At the request of Caltrans District 7, TCWG in August 2009, reviewed and concurred with the findings of a qualitative hot-spot analysis for PM10 and PM2.5 for projects LA000548 and LA0B875, Segments 2 and 3 of the I-10 HOV Lanes project from Puente Avenue to the SR-57/71 Interchange in Los Angeles County. The qualitative analysis was deemed acceptable and was subsequently circulated for public comments. FHWA determined on May 5, 2010, that the analysis conformed to the State Implementation Plan in accordance with 40 CFR Part 93.

Request for TCWG Reaffirmation of Concurrence
LA000548 and LA0B875
I-10 HOV Lanes Project
From Puente Avenue to SR-57/SR-71/I-210 JCT (Segments 2 and 3)
June 30, 2011
Page 2

L-9

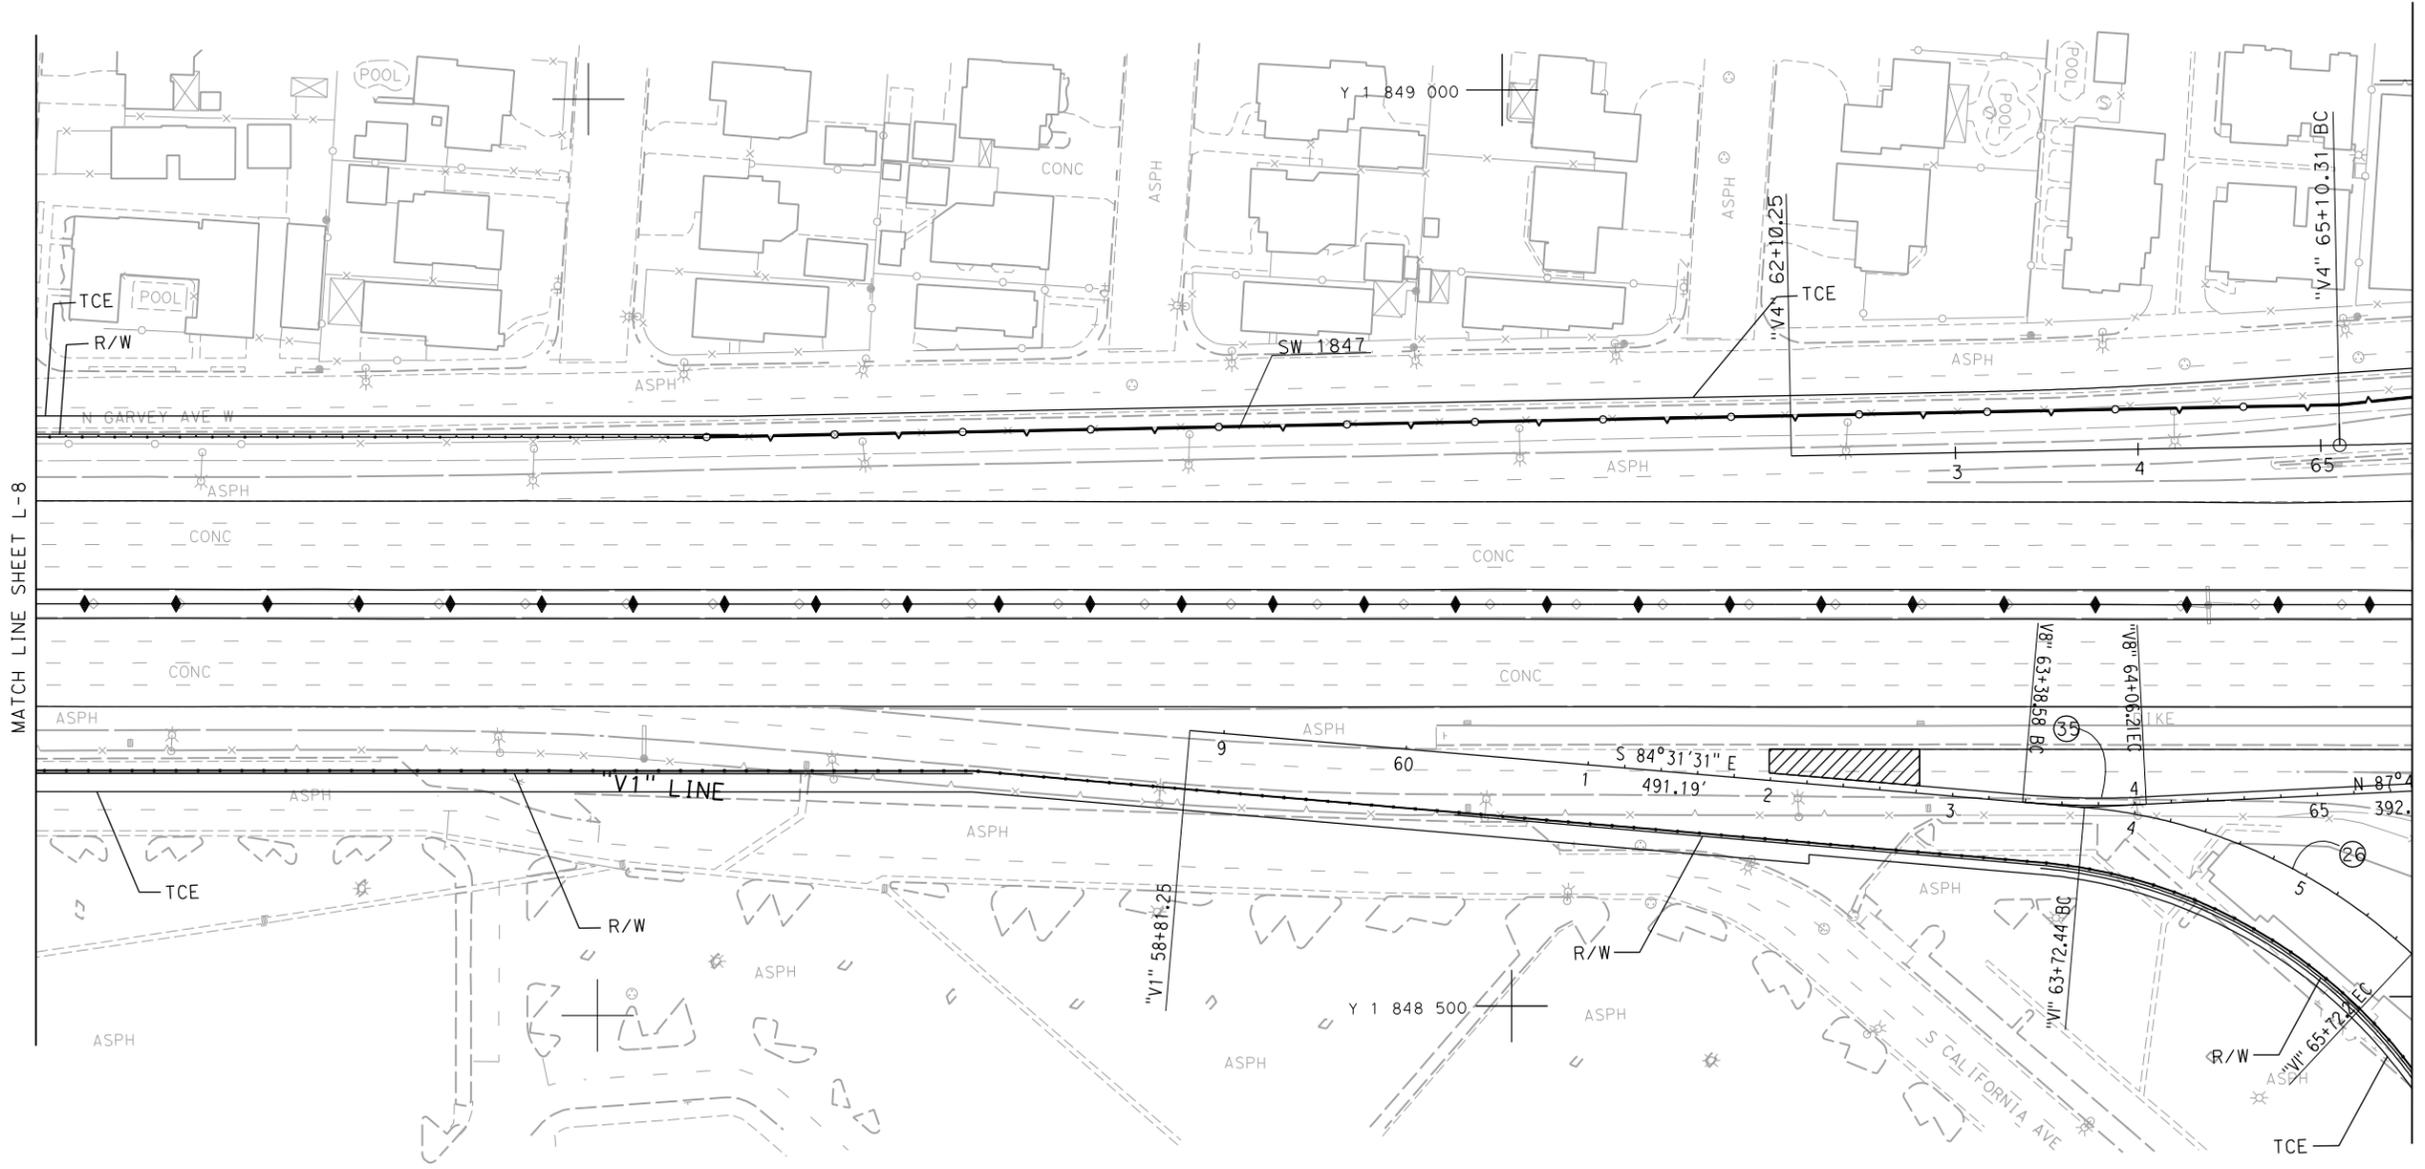
- At Vincent Ave interchange, one loop ramp (East Bound I-10 off-ramp to North Vincent Ave.) is eliminated. The East Bound I-10 off-ramp to South Vincent Ave. is re-designed. Also, the East Bound I-10 on-ramp from North Vincent Ave. is re-designed. See attached diagrams illustrating the proposed changes.
